Kroger D632 Retail Fuel Center JSP15-27

Public hearing at the request of The Project Collaborative for Special Land Use Permit, Preliminary Site Plan and Storm Water Management Plan approval for JSP 15-27 Kroger D632 Retail Fuel Center. The subject property is located in Section 17, on the north side of Grand River Avenue between Beck and Wixom Roads, in the B-2, Community Business District. The subject property is approximately 8 acres and the applicant is proposing to construct a retail fuel center consisting of one 5,418 square foot canopy, one 198 square foot kiosk building and seven dispenser islands within West Market Shopping Center.

Planning Review

PLAN REVIEW CENTER REPORT

SHEET NUMBER
C1.20

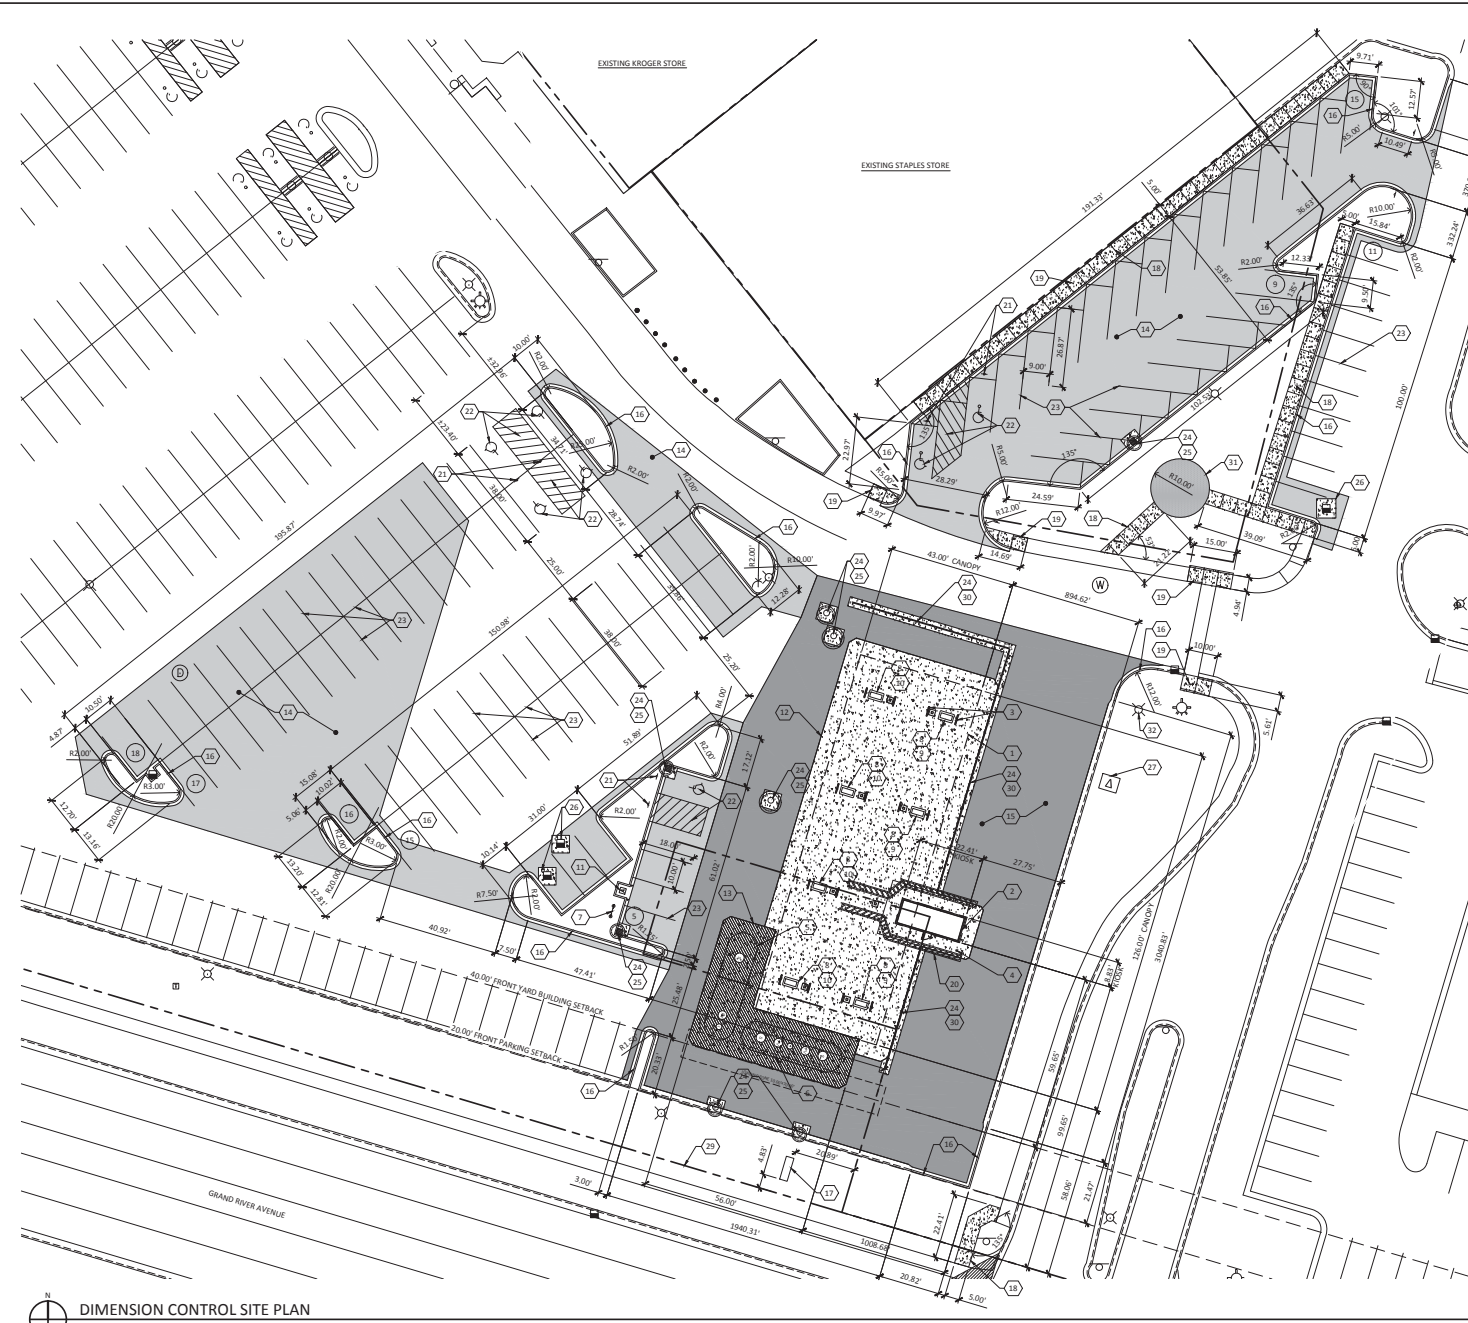
1. Canopies (Sec 4.29.1.D): *Attached canopies shall comply with building setback requirements.* **Attached canopy appears to be in compliance with setback. Please show setbacks on the Final Site Plan.**

3. Building Setbacks (Sec 3.1.11.D) Proposed building setbacks are not provided on the Preliminary Site Plan, but instead are indicated **as "XXXX" on plans. Indicate the setbacks on Final Site Plan. Plans appear to be in compliance with the minimum setback requirements of the ordinance.**

- c. Barrier-free van accessible signs (Note 21) on sheet C1.20 should be placed at the center of the parking stall and not in the hatched area.
 - d. The applicant should consider including details of the removal and replacement of the stop sign located at the exit of the Kroger/Staples parking lot.

3. Better description is needed of "Outdoor Sales" item listed on legend #28, listed on plan set (page C1.2). If this is combustible storage, it cannot be stored within 30 ft of fuel pumps. Per IFC (2009) SEC 2205.7 (Misc. Combustible Storage) and NFPA (2009) 60.1.24(2) & 60.4.11.1.3 (Clearance from Combustibles).

- Building setback lines are shown on Dimension Control Site Plan, C1.20.

- Building setback lines are shown on Dimension Control Site Plan, C1.20 and will be noted on Cover Sheet, G0.01.

- Loading zone identified on sheet C1.20. Loading zone is south of the underground fuel storage tanks.

3. A traffic control sign table will be added to C1.20. A note will also be added stating, "ALL TRAFFIC SIGNAGE WILL COMPLY WITH THE CURRENT MMUTCD STANDARDS."

22. Dimensions of the parking stalls are indicated to the face of curb on C1.20. A note will be added stating, "ALL DIMENSIONS ARE TO BACK OF CURB UNLESS OTHERWISE INDICATED."
23. Concrete curb will be identified on C1.20 as MDOT C-4 with detail on C5.00
24. Proposed paving cross sections will be included on sheet C5.00.
25. Top of curb/walk grades will be added on C1.30.
26. The actual usable length of the proposed angled parking stalls will be added to C1.20.

- III. Other details as necessary to convey design intent and the meeting of applicable City standards.
 - b. Entering and exiting radii for angled parking area will be revised per Figure IX.2 of City's standards.
